Request IR-1:

Doward – Service Complaint (NSEB M13021)
NSPI Responses to NSEB Information Requests

Request IR-2:

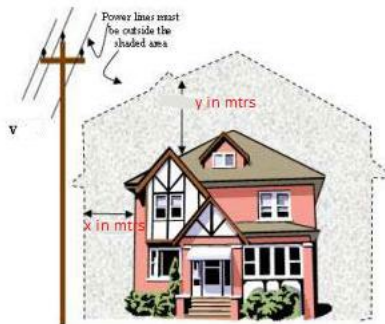
Board staff understand that two stakes have been positioned where the proposed stub pole and the buried anchor for the overhead guy wire will be installed in the Halifax Regional Municipality (HRM) right-of-way. However, Board staff also understand that, depending on the voltage of the power line, regulations provide x and y value in meters, and the power lines must be outside the shaded area as shown in the image below:

(a) Does NS Power concur with Board staff’s understanding as expressed in the above preamble?

(a) Please provide the values of x and y, along with the standards used as reference.

5 **(a) Please provide the values of x and y, along with the standards used as**
6 **reference.**

7 **(b) Please provide an envelope drawing that includes the building in**
8 **relation to the proposed installed pole, illustrating how the x and y**
9 **measurements will be taken.**

10 **(c) Please provide the measurements of x and y for the residence, assuming**
11 **that the wall of the house is considered part of the building's**
12 **protuberances.**

18
19 (ii) NS Power does not concur with Board staff's understanding as expressed in the
20 preamble. The CSA and NS Power Distribution Standards prescribe minimum
21 horizontal (x) and vertical (y) clearances between conductors, guys,
22 communications cables, drop wires, and buildings. The applicable clearance
23 requirements depend on the type of facility being assessed, the voltage level,
24 conductor type, span length, and other factors specified in the applicable standard.
25 Accordingly, the minimum clearance requirements cannot be determined solely by
26 reference to the shaded envelope shown in the preamble. The applicable points of
27 measurement and required clearances depend on the particular structure being
28 assessed and the specific provisions of the applicable standard.

1 horizontal and vertical clearance requirements are not independent of one another.
2 Where sufficient horizontal clearance exists, the corresponding vertical clearance
3 requirement does not apply. Similarly, where sufficient vertical clearance exists, a
4 reduced horizontal clearance may be permitted. The standard recognizes that the
5 objective is to maintain adequate overall separation between the facility and the
6 building and that substantial clearance in one plane can offset a reduced clearance
7 in the other plane.
